721-2024 ADDENDUM 11

NEWPCC Primary Clarification Upgrade Project

ISSUED: April 08, 2025
BY: K.C. Kiesman, EIT
TELEPHONE NO. 204 430-0563

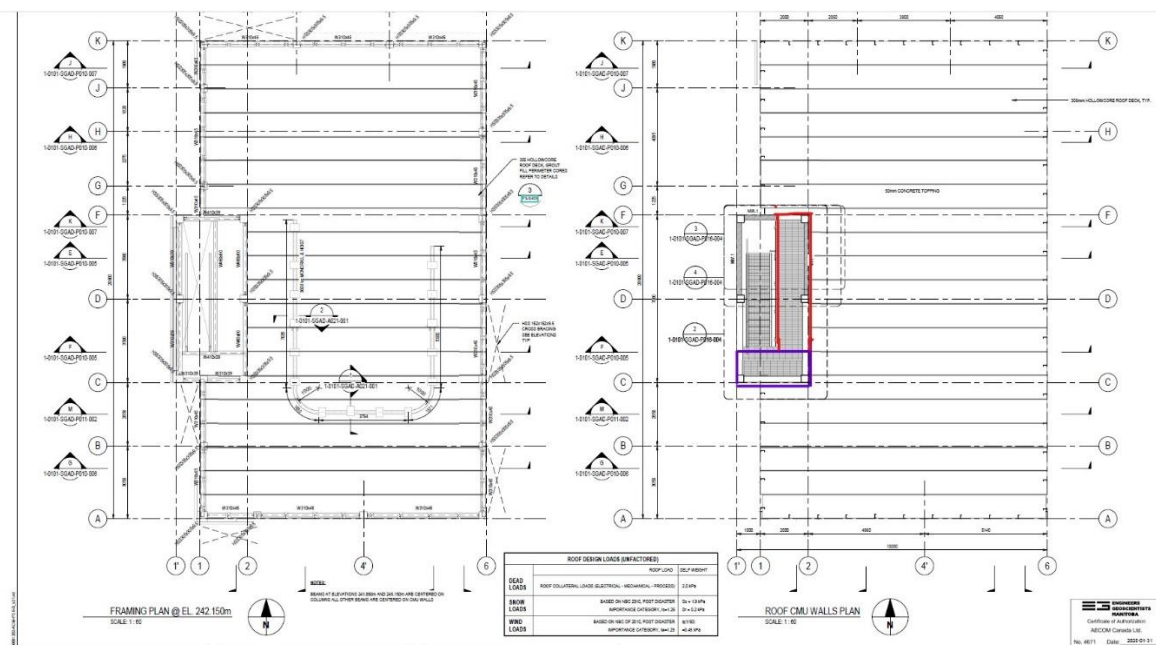
- A23 Steel piles are embedded directly into pile caps. Refer to drawing 1-0101-SFDW-P001 sheet 001.
- Q24 We would appreciate your clarification regarding the cantilever hollowcore detail shown in Section E on Drawing 1-0101-SGAD-P010, Sheet 005. Please note that if the hollowcore does need to cantilever in the purple area, this cantilever would be subject to two stair stringer point loads that we will need to estimate.

Please review the attached drawings and the screenshots below. Could you please confirm whether the cantilever length applies only to the purple area, the red area, or both?

- A24 There is no cantilevered hollowcore. All hollowcore planks to be simply supported. Please refer to updated 721-2024_Addendum_11-Drawing 1-0101-SGAD-P005-001 R01 and Drawing 1-0101-SGAD-P010-005 R01 included in Addendum 11.

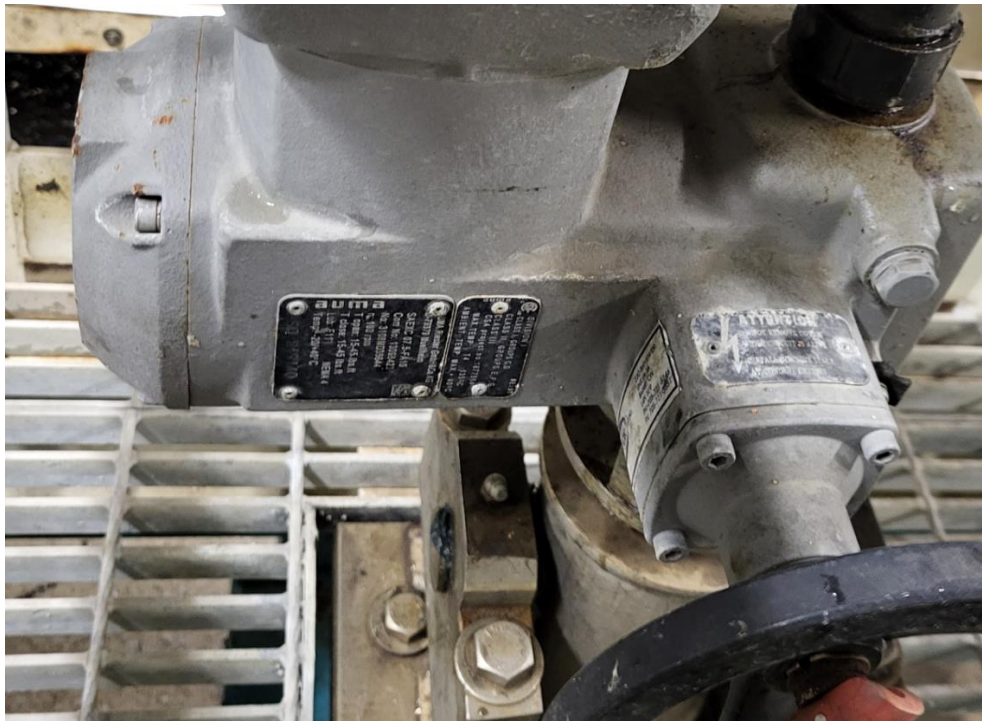
- Q28 721-2024_Drawings_Part 2 & 721-2024-Appendix_G (PDF) – Instruments, page 2 of 4: There are three (3) Rotork actuators required to be procured and mounted on three (3) existing valves (XV-P11110, XV-P11210, XV-11310, PRIMARY CLARIFIER 1,2,&3). The actuators are on P&ID 1-0101-PPID-P102-001 & instrument schedule 721-2024_Appendix_G(PDF)-Instruments, page 2 of 4. Please provide valve torque details for actuator sizing and valve top work details for mounting kit to allow vendors to price accordingly.

- A28 Torque calculation is part of contractor scope when actuator is selected as per spec section 23 09 23 .11 1.4.4. however, for reference only, existing actuator nameplate is provided below.
